FAQ Number 13-0002 FAQ Revision 0m!

FAQ Title Modeling of Main Control Room Abandonment on Loss of Habitability

Plant: Various Date: 3 July 2013

Figure 1 - Flow Chart for Abandonment Due to Loss of Habitability (LOH)

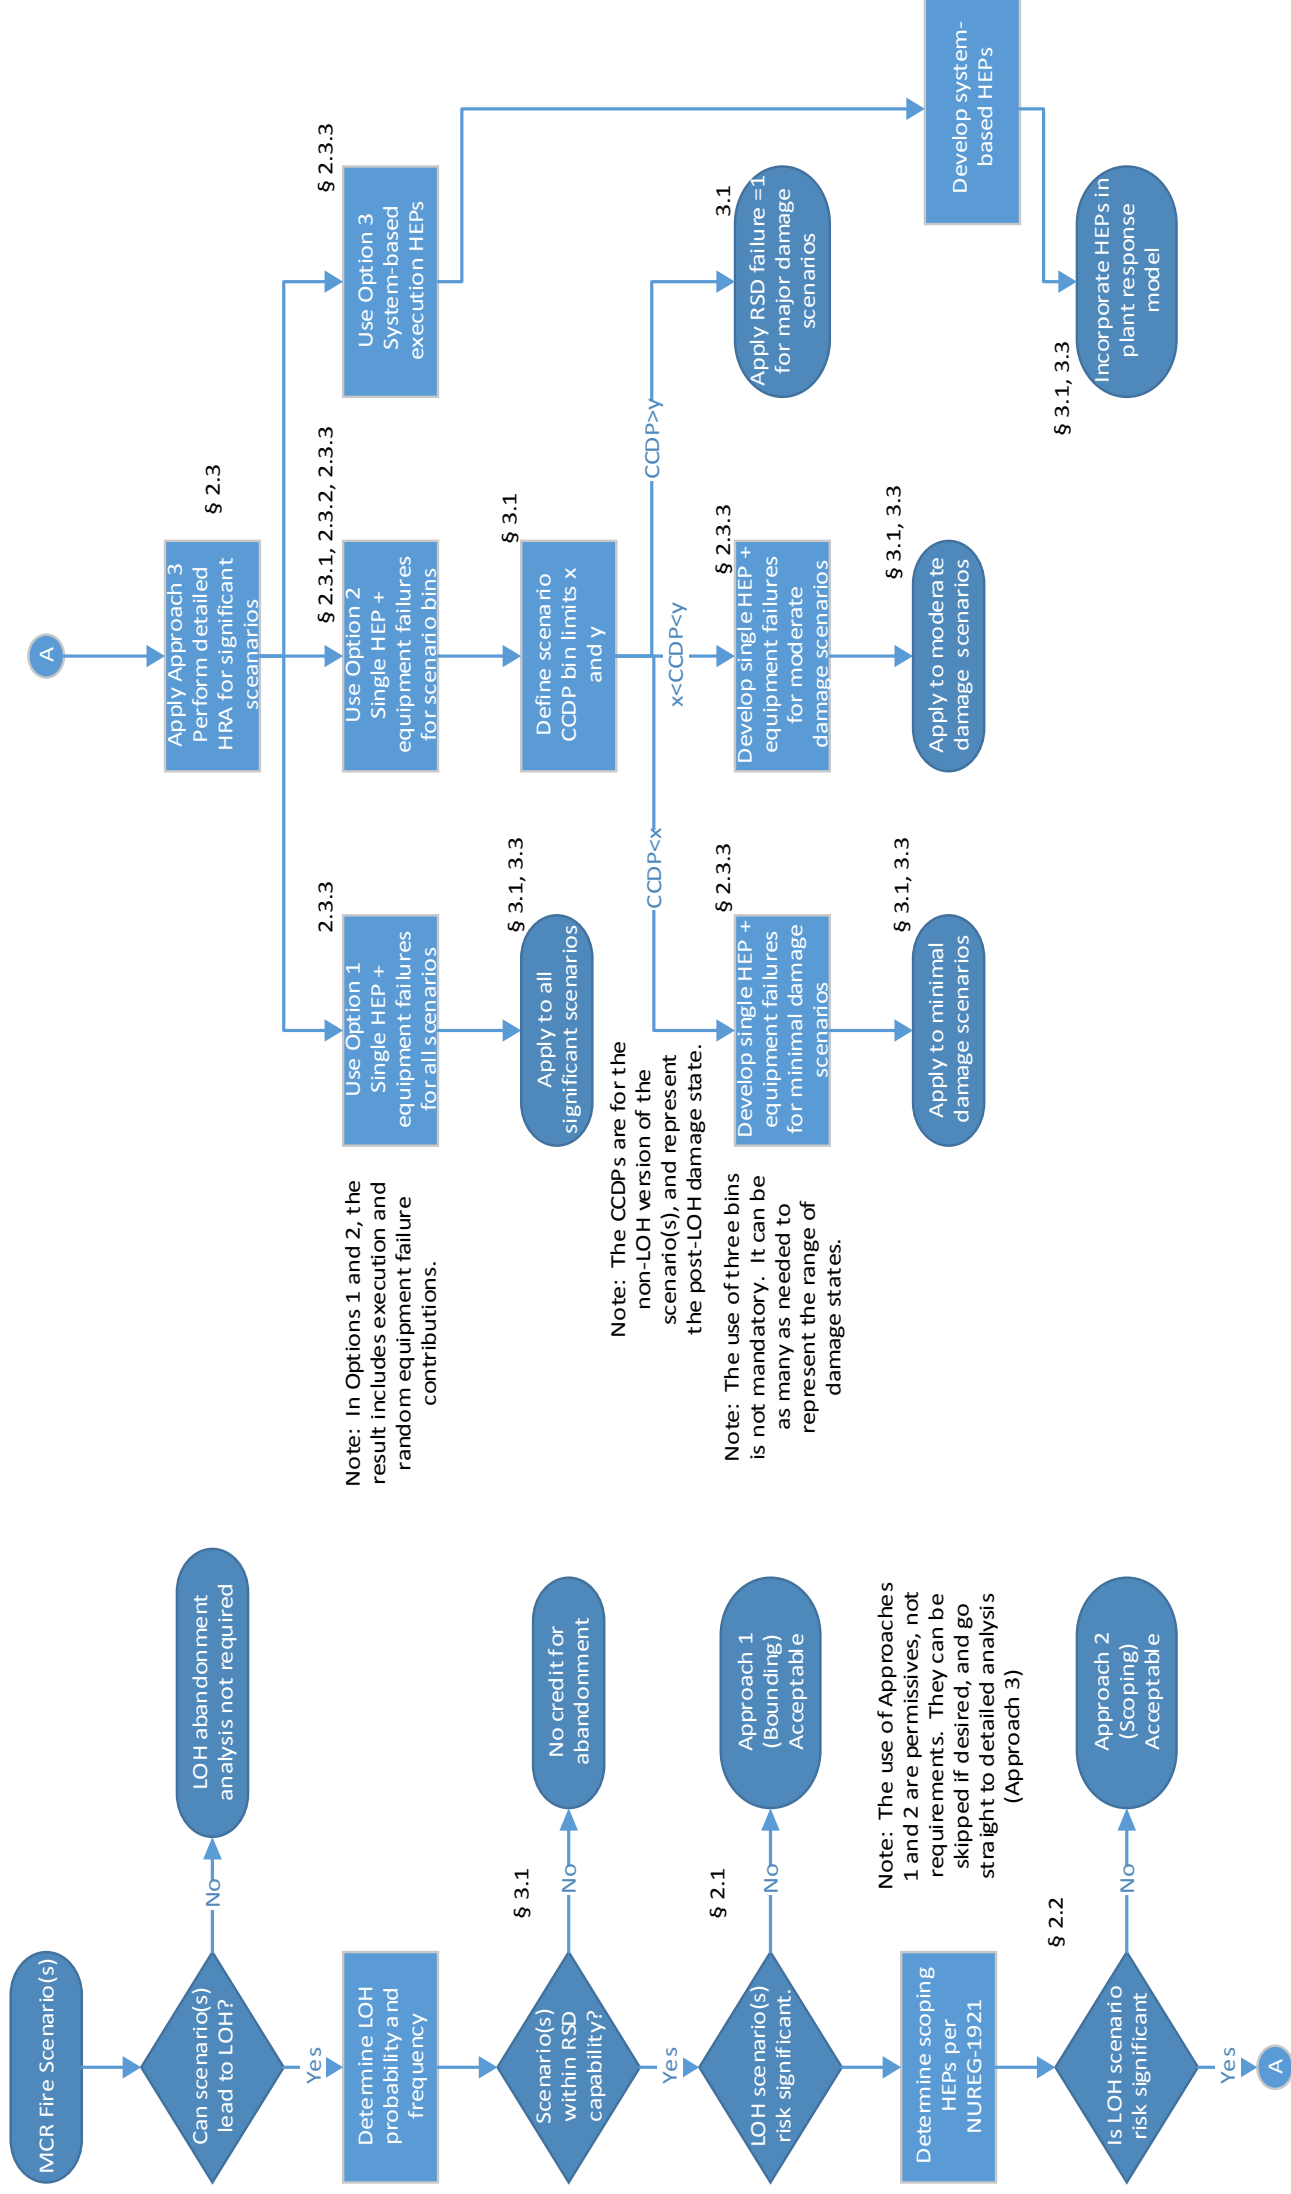
Appropriate modeling for each of these is outlined in Figure 1. The process steps in the flow charts are described in the text below, which describe the various approaches and options. The “approaches” address differences in the human reliability analysis modeling, and the “options” describe different ways to incorporate the resulting human failure event into the Fire PRA model.

It should be noted that equipment failures that preclude successful execution also need to be considered in the analysis. As with the HRA aspects, there is more than one approach to modeling this, and these are also discussed in the FAQ. The flow chart is applied to each fire scenario (or group of similar scenarios) that occurs in the control room.

conditions (e.g., unisolated stuck open atmospheric relief valves for PWRs) or in cases where fire damage (e.g., multiple spurious operations) could result in unrecoverable loss of the remote shutdown capability. Therefore, if the fire causes these conditions and they are not recoverable as part of the abandonment procedure, then core damage should be assumed. An assessment of the conditions that would preclude success would be determined for the specific plant, and the model developed to reflect that abandonment credit could not be applied to fire scenarios that caused these conditions. This is represented on the flow chart by the decision diamond labeled "Scenario(s) within RSD capability?" where an answer of No leads to the terminus labeled "No credit for abandonment."
